## SERVICE INSTRUCTION

# Change of oil cooling of stator for ROTAX® Engine Type 915 i A (Series) and 912 i (Series)

Change of oil cooling of stator for ROTAX Engine Type 915 i A and 912 i (Series).

Fig. 1

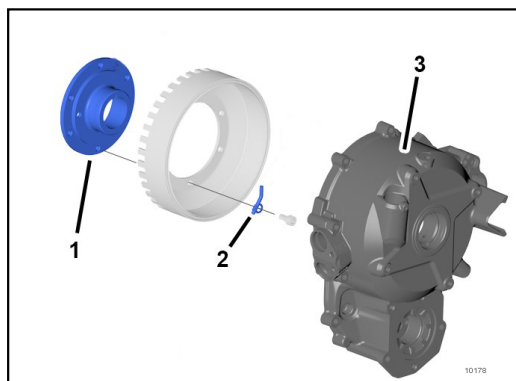
See Fig. 1.

- 1 Sprag clutch housing
- 2 Oil spray nozzle
- 3 Ignition housing

Do not mix old and new parts!  
The sprag clutch housing part no. 852409 (with oil spray nozzle) must only be paired with ignition housing part no. 912248.

Fig. 2

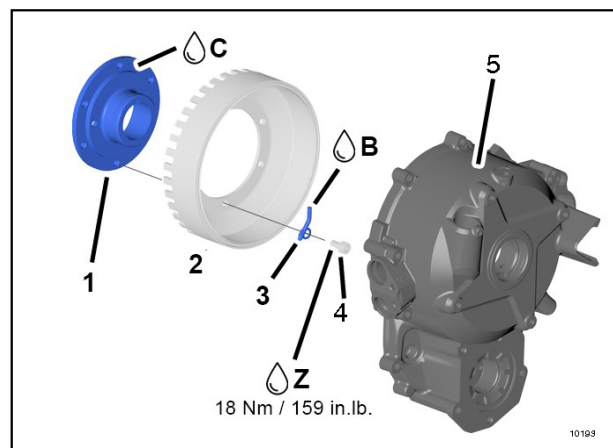
See Fig. 2.

- 1 Sprag clutch housing
- 2 Magneto flywheel assy.
- 3 Oil spray nozzle
- 4 Allen screw M6x12
- 5 Ignition housing

**B** LOCTITE 243  
**C** LOCTITE 648  
**Z** LOCTITE 603

Fig. 3

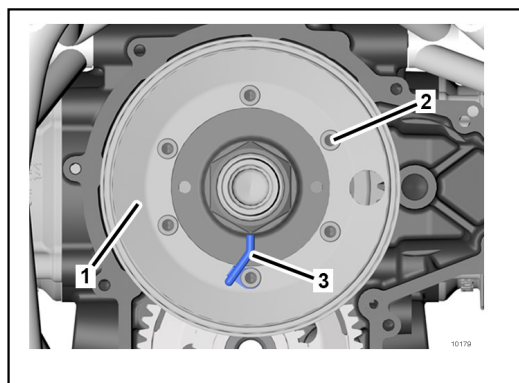
| Step | Procedure   |
|------|---|
| 1    | Loosen 6 Allen screws M6x12.  |
| 2    | Remove the oil spray nozzle from the sprag clutch housing.<br>Note: The nozzle is secured with LOCTITE 243. |
| 3    | Remove magneto flywheel assy.   |

1 Magneto flywheel assy.  
2 Allen screw M6x12  
3 Oil spray nozzle

Fig. 4

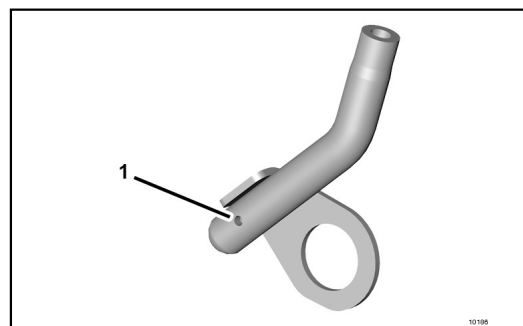
| Step | Procedure   |
|------|---|
| 1    | Check that the oil passage is clear.<br>Note: The oil passage is 0.8 mm (0.030 in.) in diameter. Check using a 0.5 mm (0.020 in.) wire. Use a wire with appropriate material specification (e.g. cooper, brass,...) in order to avoid damage to the inside of the oil spray nozzle. |

1 Oil passage

Fig. 5

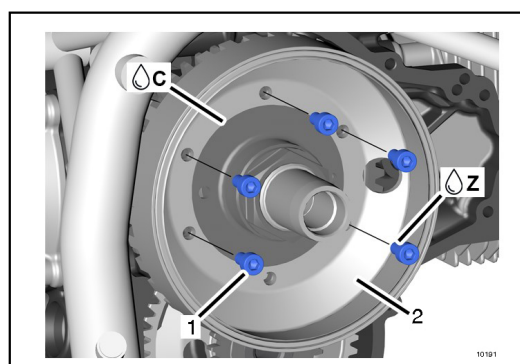
| Step | Procedure  |
|------|--|
| 1    | Apply a small thin layer of LOCTITE 648 to the flat surface of the sprag clutch housing. |
| 2    | Place magneto flywheel assy. on top.   |
| 3    | Secure 5 Allen screws M6x12 (12.9 screw strength) with LOCTITE 603.                      |

1 Allen screw M6x12  
2 Magneto flywheel assy.

Fig. 6

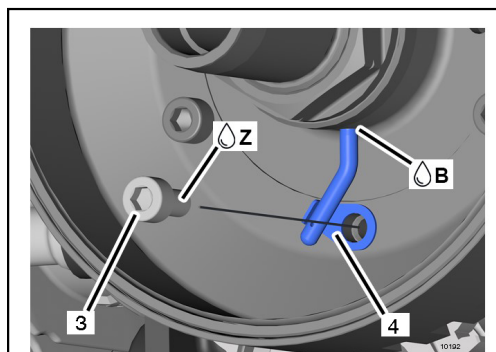
| Step | Procedure   |
|------|---|
| 1    | Apply a small amount of LOCTITE 243 to open end of the oil spray nozzle.<br>Note: Make sure oil supply passage does not get blocked by LOCTITE! |
| 2    | Place the oil spray nozzle assy. into the sprag clutch housing bore.  |
| 3    | Secure Allen screw M6x12 (12.9 screw strength) with LOCTITE 603 and tighten all 6 screws. Tightening torque 18 Nm (159 in. lb.).                |

3 Allen screw M6x12  
4 Oil spray nozzle assy.
